**CITY OF COLUMBUS
BOARD OF ZONING APPEALS
(September 25, 2012 Meeting)**

STAFF REPORT

Docket No. / Project Title: C/DS-12-23 (Sunright America)
Staff: Derek Naber
Applicant: Sunright America, LLC
Property Size: 33.09 Acres
Current Zoning: I-3 (Industrial: Heavy)
Location: 6205 South International Drive, in the City of Columbus

SHEET TITLE
OVERALL LANDSCAPING PLAN

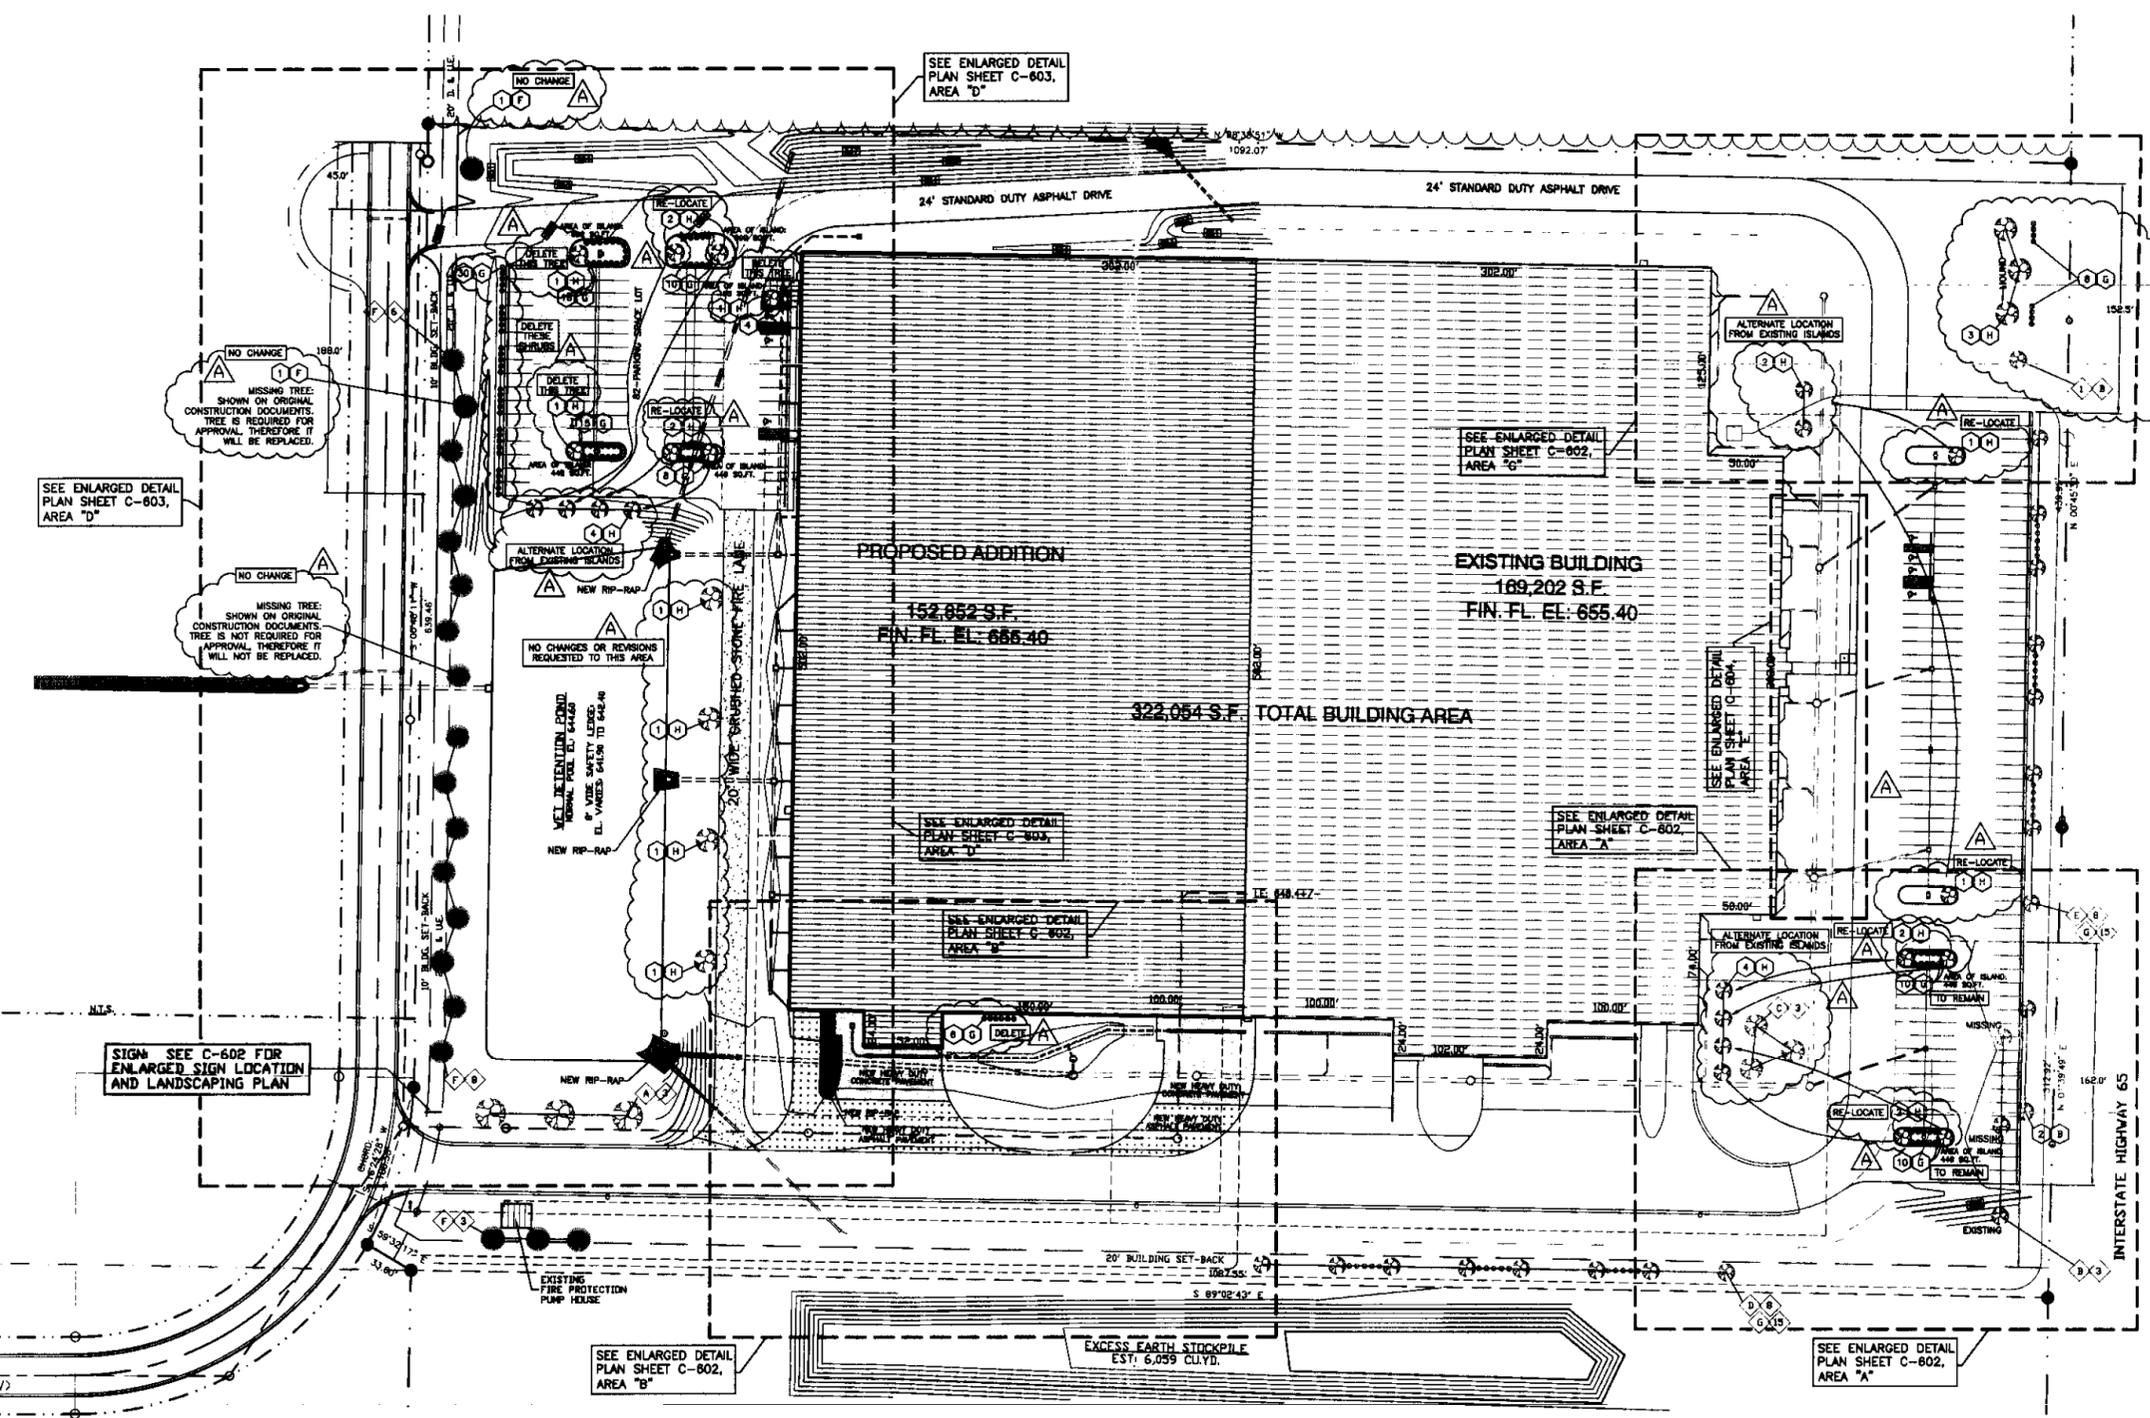
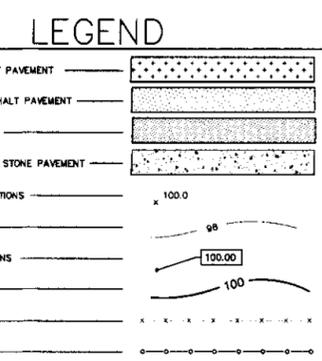
NO CHANGE
 MISSING TREE: SHOWN ON ORIGINAL CONSTRUCTION DOCUMENTS. TREE IS NOT REQUIRED FOR APPROVAL, THEREFORE IT WILL NOT BE REPLACED.

NO CHANGE
 MISSING TREE: SHOWN ON ORIGINAL CONSTRUCTION DOCUMENTS. TREE IS NOT REQUIRED FOR APPROVAL, THEREFORE IT WILL NOT BE REPLACED.

REVISIONS:
 NO CHANGE
 EXIST. NEW
 2 F + 1 F + 1 F + 1 F - DELETE
 EXIST. NEW
 1 B + 3 H + 8 G - NO CHANGE
 REPLACE 2-ORNAMENTAL TREES AT THE NEW LOCATIONS SHOWN.
 2 B - NO CHANGE

REVISIONS:
 NO CHANGE
 EXIST. NEW
 13 H + 72 G

REVISIONS:
 NO CHANGE
 EXIST. NEW
 4 H + 1 G - DELETE

SHEET TITLE
ENLARGED LANDSCAPING PLAN AREA "E"

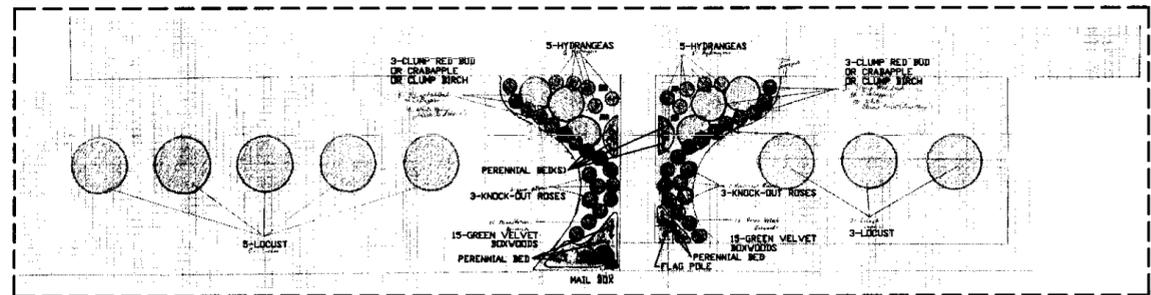
PROPOSED LANDSCAPING AT EXISTING BUILDING ENTRY (UNDER VARIANCE SUBMITTAL)
